**Proposed Residential Development
Keresforth Road, Dodworth
Supplementary Transport Assessment 3**

Proposed Residential Development Keresforth Road, Dodworth Supplementary Transport Assessment 3

LTP Quality Control					
Job No:	LTP/23/4283	File Ref:	Keresforth Road Dodworth STA3 Final Issue 1		
Issue	Revision	Description	Author	Checked	Date
1	-	Final issue for planning	AC/MR	SW	10/01/2024
Authorised for Issue:				SW

AA.23.06.07 Land north of Keresforth Road, Dodworth

Figure 2: M1 Dodworth Roundabout Aerial Imagery

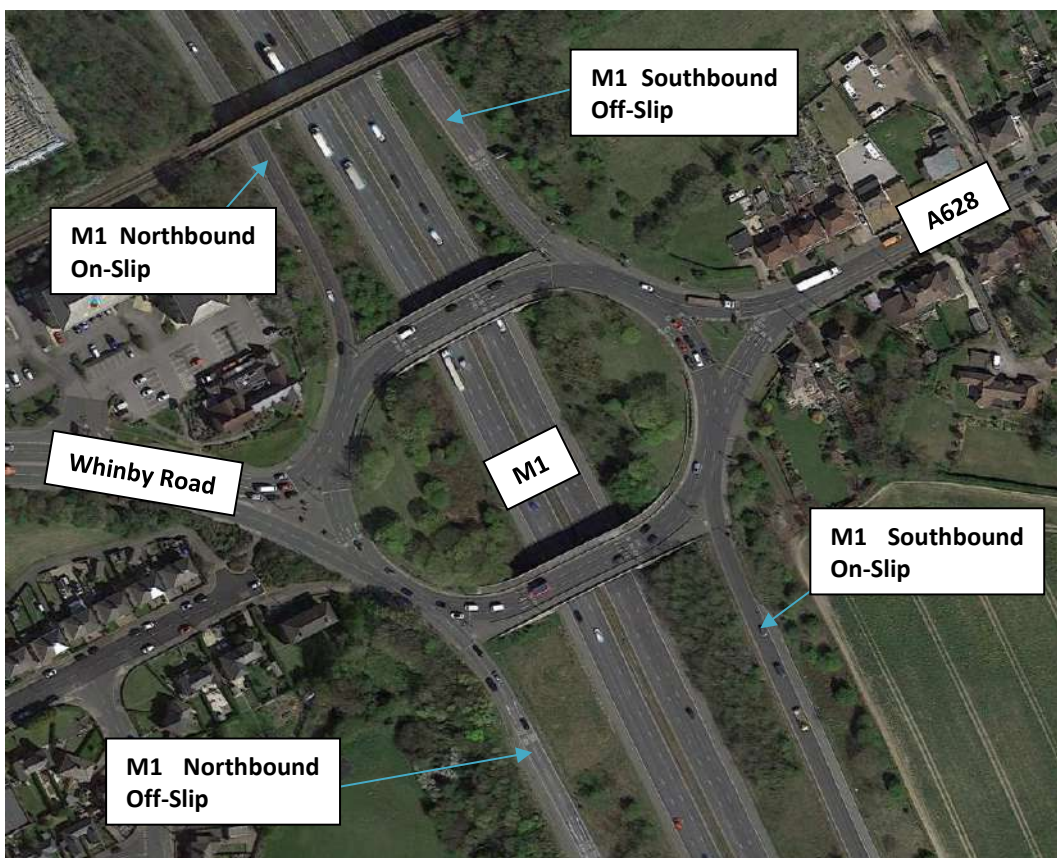
"For the M1 Junction 37 capacity assessment, National Highways will withhold judgement on the results until the points identified have been addressed, this includes:

- A calibrated and validated model has been used, National Highways recommends that LTP obtains the model developed by Fore Consulting that has been approved by National Highways;
- Clarification of the committed development traffic flows; and
- Undertaking an opening year assessment.”

LTP Response: In order to assess the ability of the M1 Dodworth Roundabout (Junction 37) to accommodate traffic associated with the proposed development, a junction capacity assessment has been undertaken using LinSig v3 modelling software. An aerial image of the M1 Dodworth Roundabout can be seen in Figure 2.

As requested by NH/JSJV, LTP has obtained a copy of the LinSig models from FC that were used to inform the TAA (FC, 2023), as these models have been accepted by NH/JSJV.

The results of the capacity assessments indicate that the M1 Dodworth Roundabout would be expected to operate within capacity during the AM peak hour in the future year scenarios, with positive levels of PRC with the proposed development in place. The modelling results indicate that the M1 Dodworth Roundabout would operate with negative levels of PRC during the PM peak hour both with and without the development coming forward.

The modelling results show that the majority of approaches are predicted to operate with Degree of Saturation (DoS) values of less than 90% in the future year assessment scenarios, which is indicative of traffic streams with reserve capacity. During the weekday PM peak hour, in the '2026 With Development' scenario, the A628, M1 Northbound and Southbound off-slips are predicted to operate with DoS values in excess of 90% but within 100%. The A628 approach is expected to operate above 90% DoS with an average maximum queue of 28.9 PCUs which is an increase of 7.2 PCUs when compared to the '2026 Do Nothing' scenario. As per the conclusions presented within the TAA (FC, 2023), the increase in queuing is not considered to be significant with sufficient stacking space to accommodate the queue without impacting upstream junctions.

In terms of the peak hour queuing extents, the predicted queues can be satisfactorily accommodated within the existing stacking space on the roundabout approaches, as demonstrated in Table 4 below which is consistent with the results presented within the TAA (FC, 2023).

Figure 1: Site location in relation to the Strategic Road Network (© OpenStreetMap contributors)

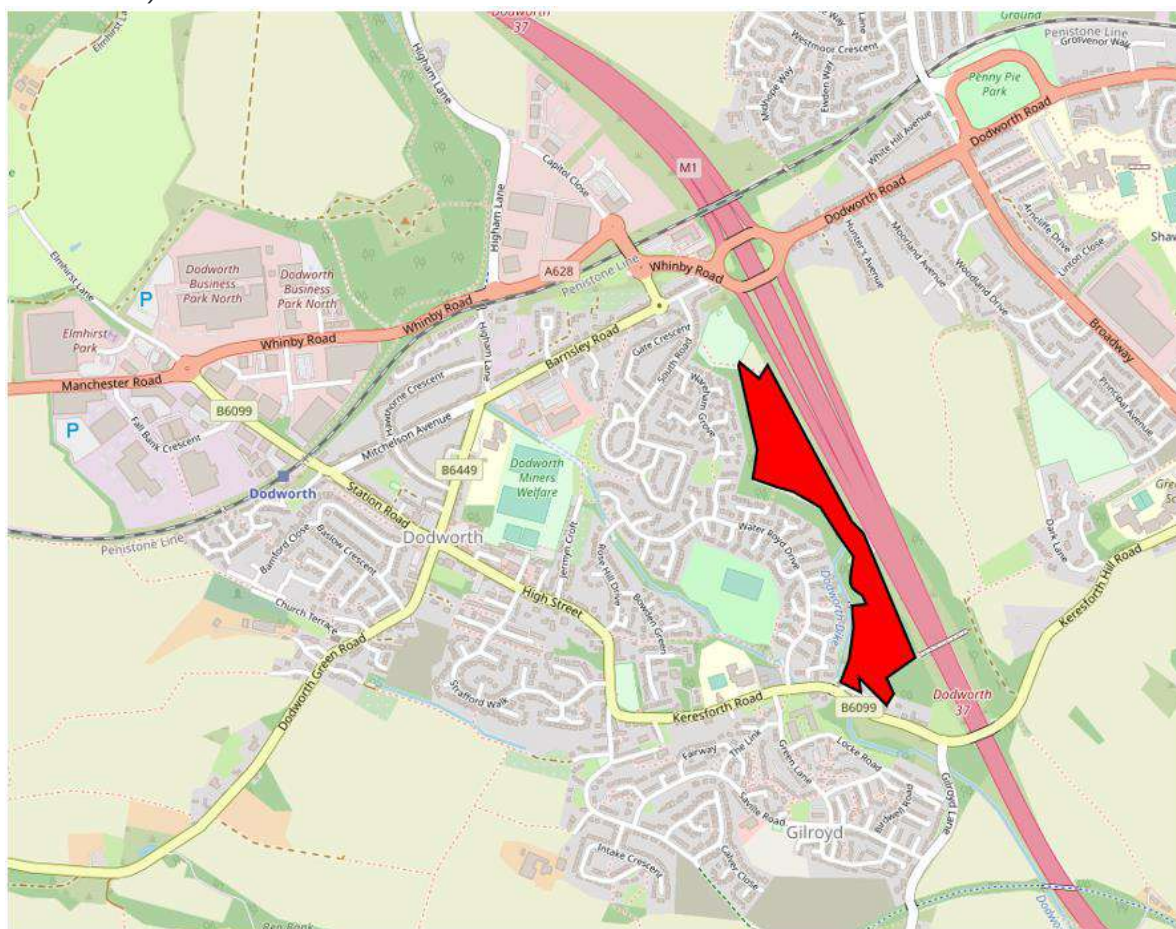
JSJV understand that the application site [Figure 1] is allocated within the adopted BMBC Local Plan (2019) as:

JSJV would note that the current Keepmoat Homes application is for the construction of 215 dwellings, i.e., a yield of 40 more than is allocated; as such, with reference to paragraph 45 (Circular 01/2022) the application is not wholly in accordance with the allocation.
